## SITE PLAN REVIEW AND APPEARANCE BOARD STAFF REPORT

### Virginia Philip Wine

Meeting	File No.	Application Type
August 23, 2023	2023-143-SPF-SPR-CL1	Class I Site Plan Modification
Property Owner	Applicant	Agent
Delray Wine Concepts	Virginia Philips	Virginia Philips

Consideration of a Class I Site Plan Modification associated with modifications to the architectural elevations.

**Proposed West Elevation**

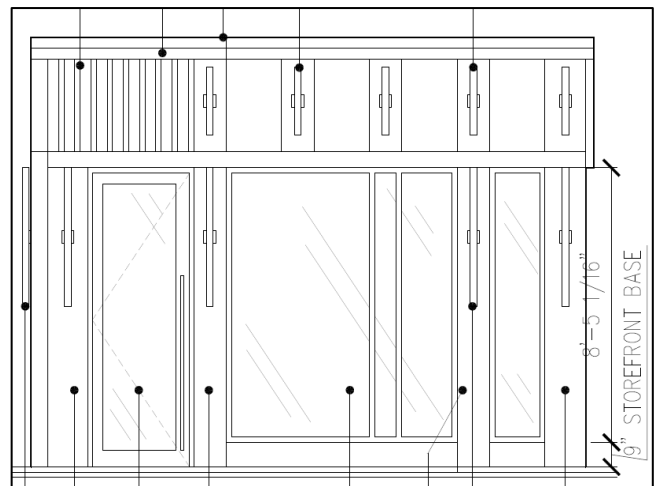
- Removal of the storefront transom, frame and glazing, storm shutters and tracks, exterior door and frame, and exterior goose neck light fixtures.
- Replacement of existing storefront with impact windows and doors, vertical light Cherry Wood elements, coping around the building, and new wall sconces and exterior lighting.

### Proposed North Elevation

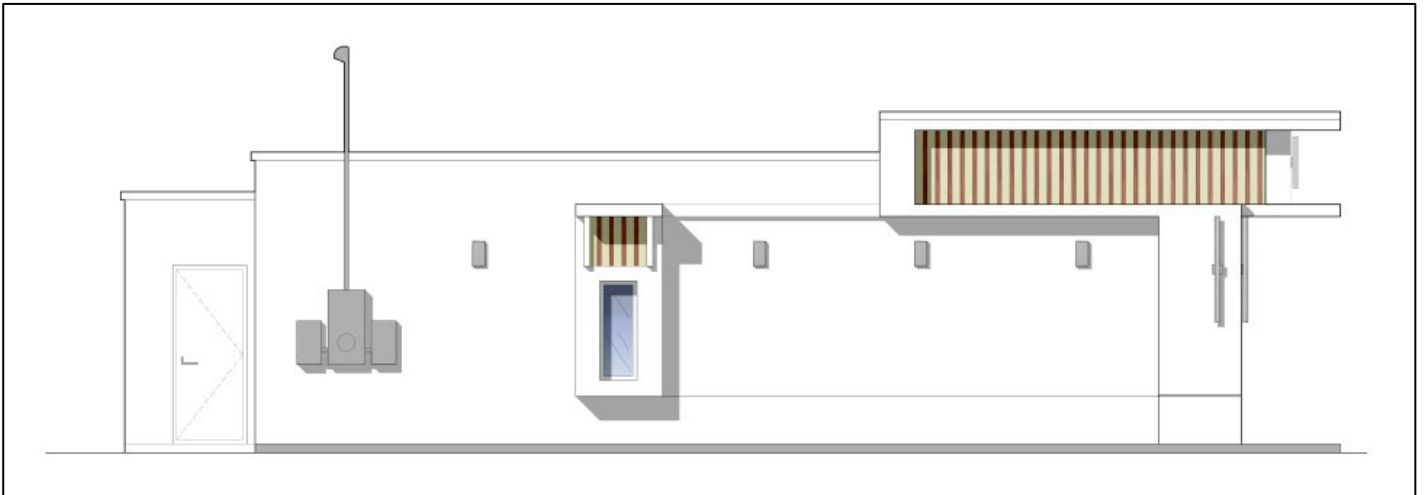
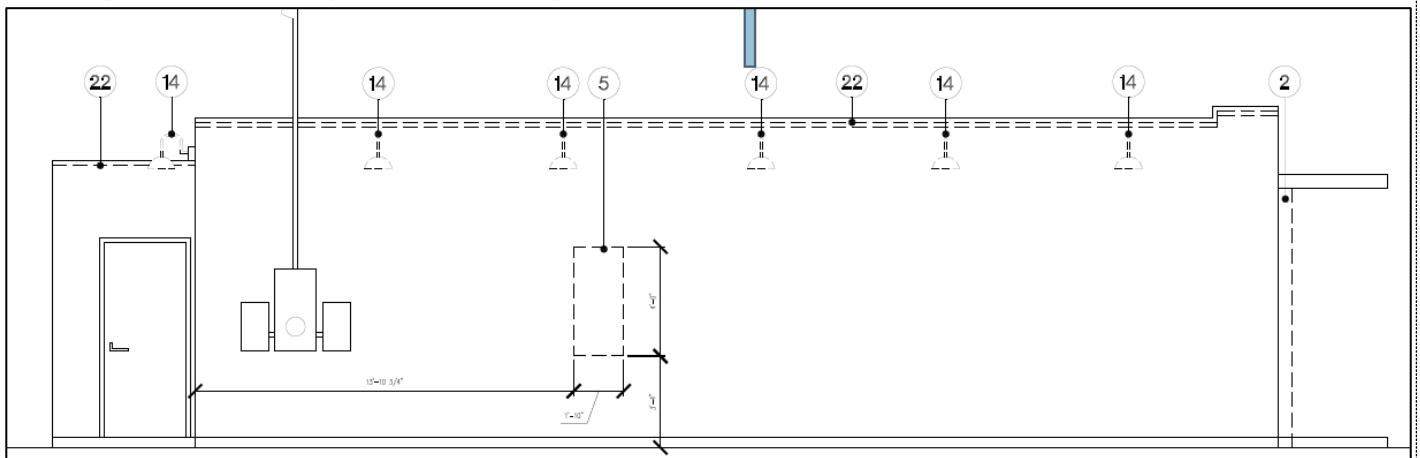
- Removal of the mural on the north façade.
- Replacement of the windows and doors on the east elevation and new opening on the north elevation with impact windows and doors.
- Paint existing stucco, coping, and accents white.
- Vertical Cherry Wood elements are incorporated onto the north elevation to form the parapet with accents of the vertical Cherry Wood on the window.
